UNITED STATES PATENT AND TRADEMARK OFFICE  
**CERTIFICATE OF CORRECTION**

PATENT NO. : 7,151,218 B2  
APPLICATION NO. : 10/764105  
DATED : December 19, 2006  
INVENTOR(S) : Cong Thanh Dinh

(54) **ELECTRICAL TERMINATION COMPONENT  
BRACKET**

Sheet 1 of 5

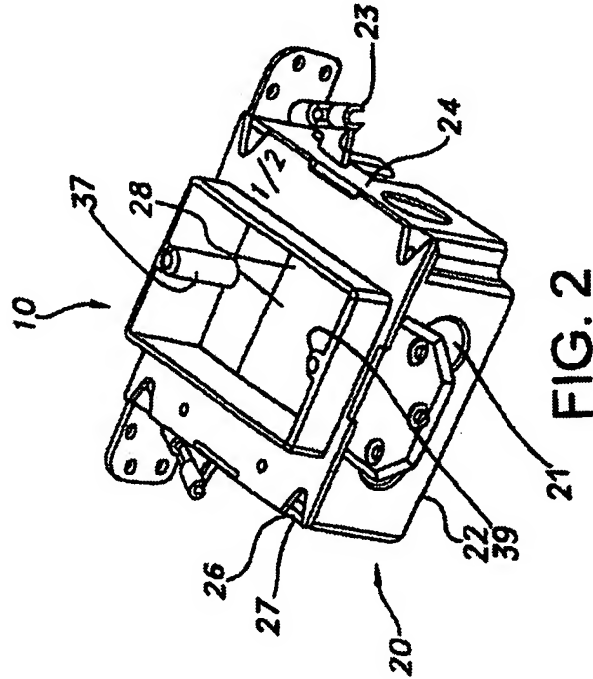
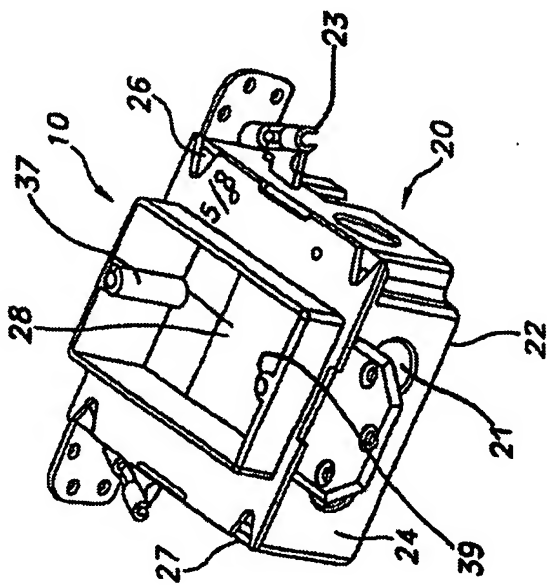
In Figure 1, previously omitted elements 21, 23, 37, and 39 have been added.

In Figure 2, previously omitted elements 21, 23, 37, and 39 have been added.

Sheet 3 of 5

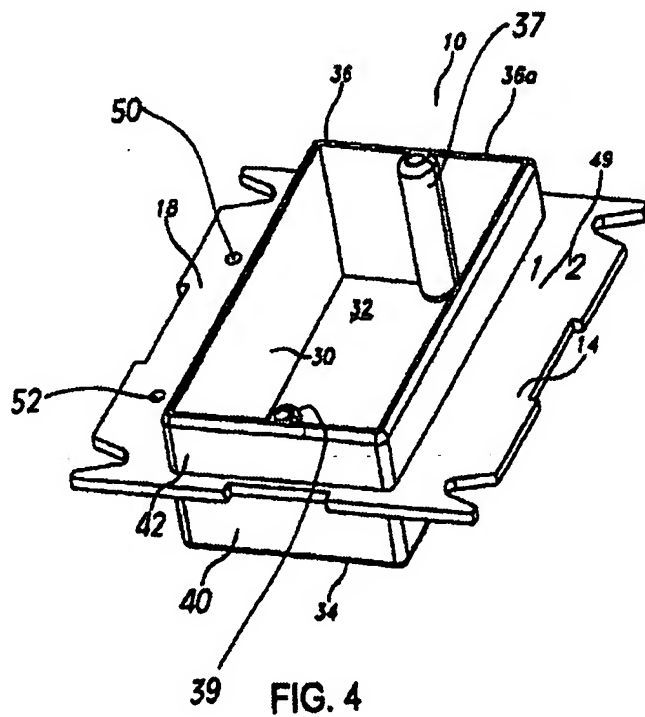
In Figure 4, previously omitted elements 37, 39, 50, and 52 have been added. Also, element "42" was replaced with element --40-- and element "40" was replaced with element --42--.

FIG. 5

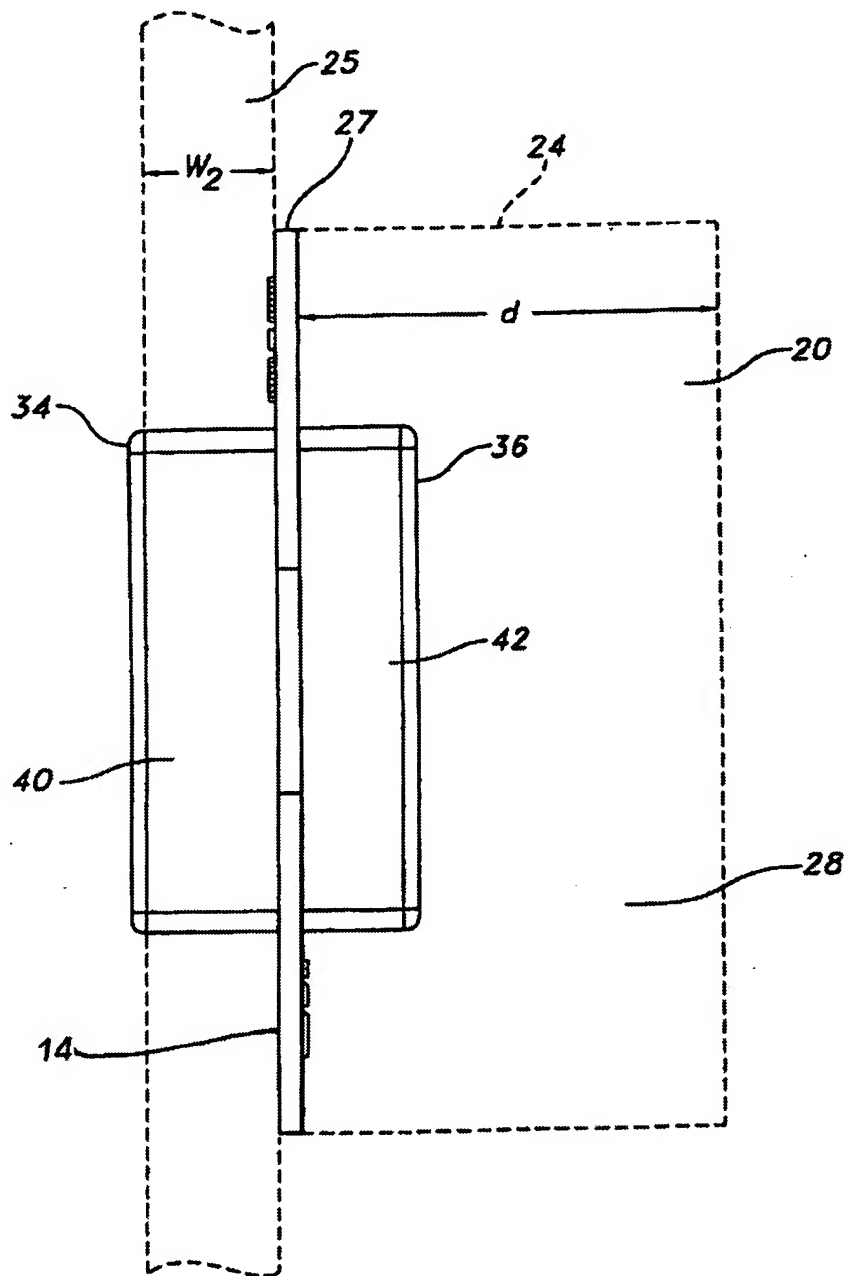
In Figure 5, previously omitted element 14 was added.

FIG. 6

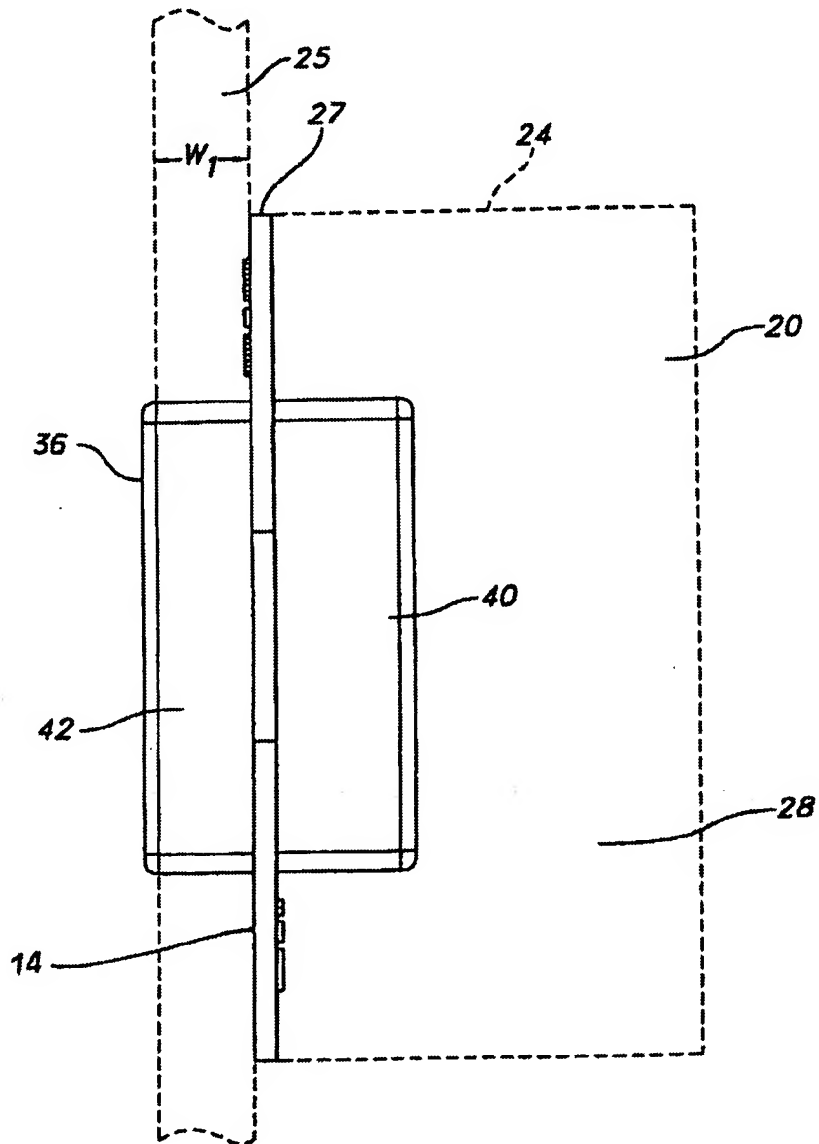
In Figure 6, previously omitted element 14 was added. Also, element "34" was replaced with element --36--.
